SUTHERLAND SHIRE COUNCIL ASSESSMENT REPORT

| Panel Reference | PPSSSH-171 |
| DA Number | DA24/0369 |
| Street Address | 1323-1329 Princes Highway, Heathcote |

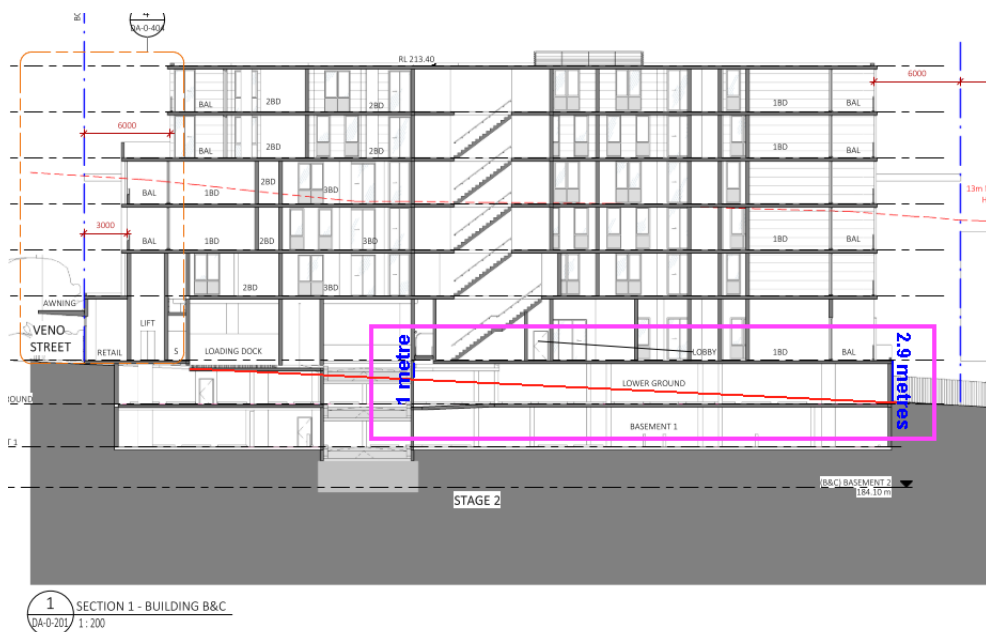
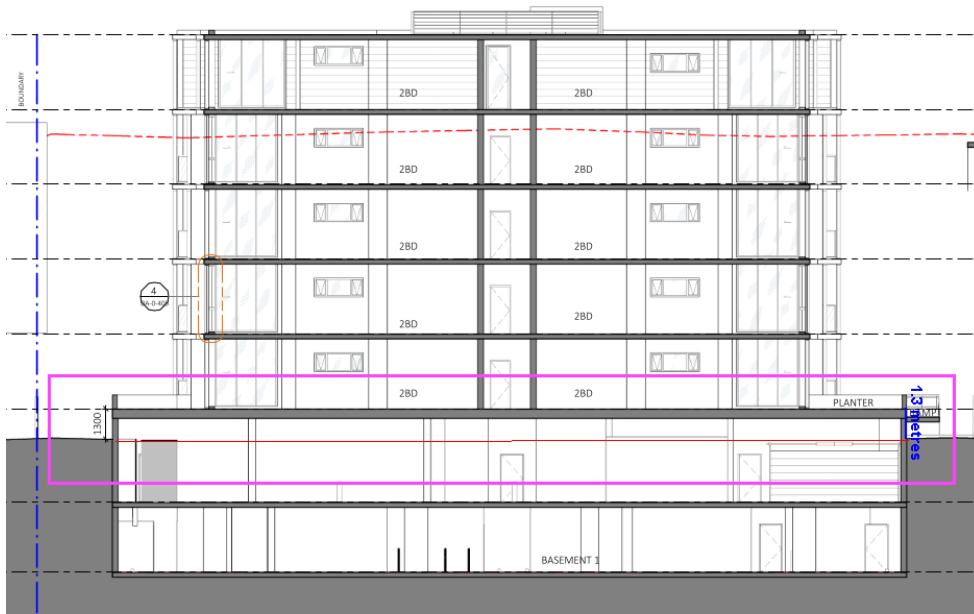
The assessment has established that the applicant has incorrectly calculated the GFA as they have failed to include the following:

- The non-basement waste rooms.
- Thicknesses of walls surrounding lift shafts and services rooms – all buildings.
- The storage room associated with the communal open space on the top level of Building A.
- The access lobby area for Buildings B and C.
- The private open space/balcony areas where 50% or more of the opening is screened.

When these areas are included, the proposal has a GFA of 16,829.4m² or an FSR of 2.23:1. Based on this GFA, a minimum 1,683m² of the total GFA must be allocated for the affordable housing apartments. The application has a current affordable housing GFA shortfall of 78m². As the application fails to provide the minimum 10% of the GFA for affordable housing, the proposal does not gain any benefit from the HSEPP and as such, the provisions of SSLEP2015 apply. Based on a GFA of 16,829.4m², the proposal exceeds the maximum permitted GFA prescribed by Clause 4.4 from SSLEP2015 by 2,339.4m², equating to a contravention of 116.14%.

Images 7, 8 and 9: Section Plan extracts showing the extent of the basement levels that are more than 1m above the existing ground level which have not been included in the applicant's FSR/GFA assessment of compliance

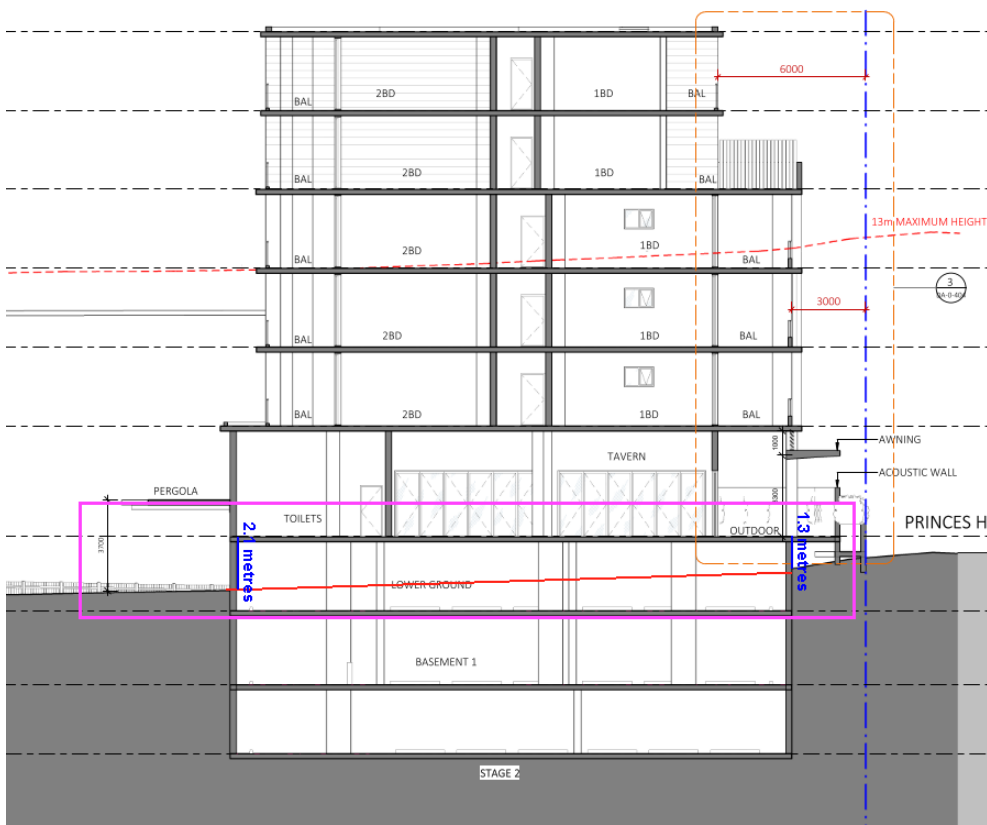
In addition to the above, a review of the plans shows that there are substantial basement areas that protrude more than 1m above the existing ground level. In accordance with the basement definition from the Standard Instrument Order, that part of the basement that is more than 1m above the ground comprises a storey and is therefore included in the calculation of GFA and FSR.

Drawings DA0401D (Section 1 Building B and C), DA0402D (Section 1 Building A), DA0403N (Section 2 Building C) shows the basements protrude above the ground by 2.9m, 1.3m and a maximum 2.1m respectively. There is no drawing/section plan through the length of Building C. Drawing DA-0-243B Ground Level Plan for Building C shows the northern outdoor area and a significant portion of the eastern outdoor area will be constructed well above 1m above the existing ground level. Therefore, the subfloor area below constitutes GFA.

The following plan extracts show those parts of the basement levels that comprise GFA:

An assessment of compliance cannot be established as the application lacks the necessary details and information for a calculation to be undertaken, particularly additional section plans that show the true extent of the basement and floor areas above the ground level. Having regard to the aforementioned drawings, the proposal significantly exceeds the maximum permitted GFA and cannot be supported.
